ADDENDUM #4

Essexville-Hampton Public Schools
New Innovation Center Project
September 14, 2026

Project: EHPS New Innovation Center Project

RE: Pre-Bid RFI Response

Drawing
Lighting Plan

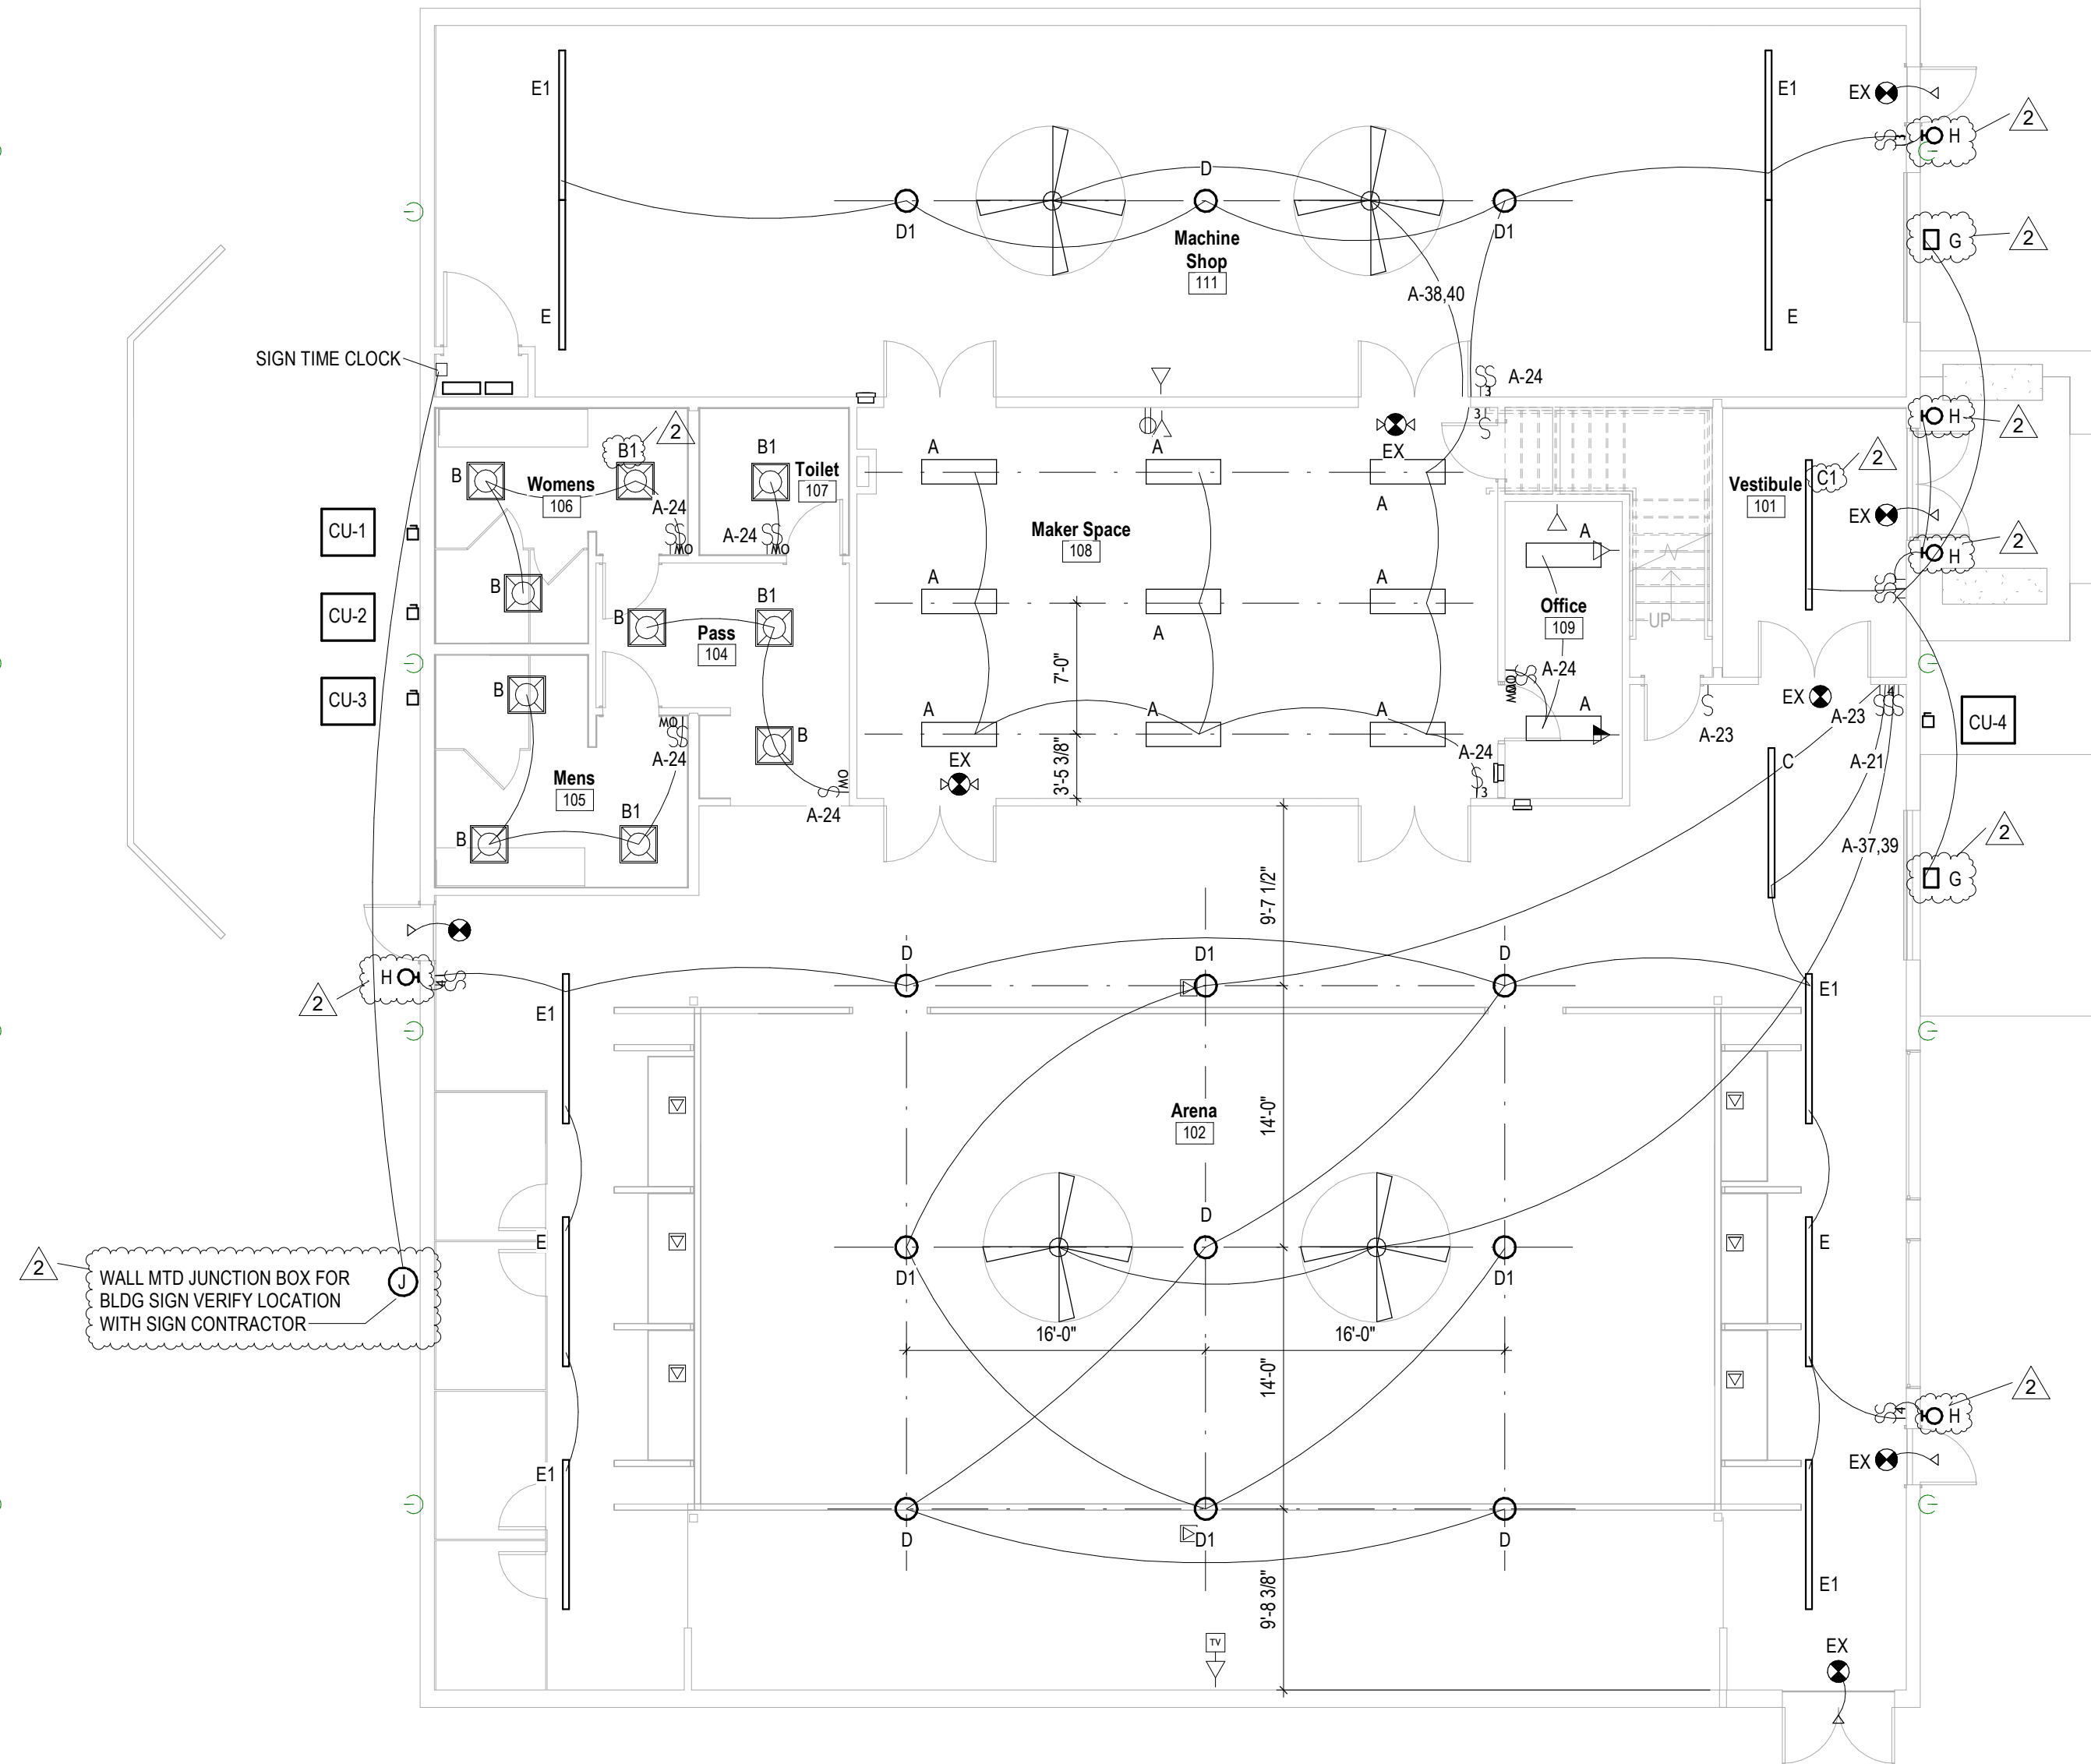
5. Does the current light fixture schedule for room 111 meet the hazardous location requirements asked for in this room? Will there be a revised lighting schedule?
 - a. Revised lighting schedule on re-issued E1.1 - Lighting Plan. Include pricing for Lithonia Petrolux PXHW and EMXH.

- a. Refer to new sheet E2.0 - Electrical Specifications.
4. Drawing E1.1 shows Type E/E1 fixtures in Machine Shop 111 and they do not appear to be rated for this location; are we to include this fixture or will an alternative be provided by the engineer?

- a. An alternative has been provided. Refer to re-issued sheet E1.1 - Lighting Plan.
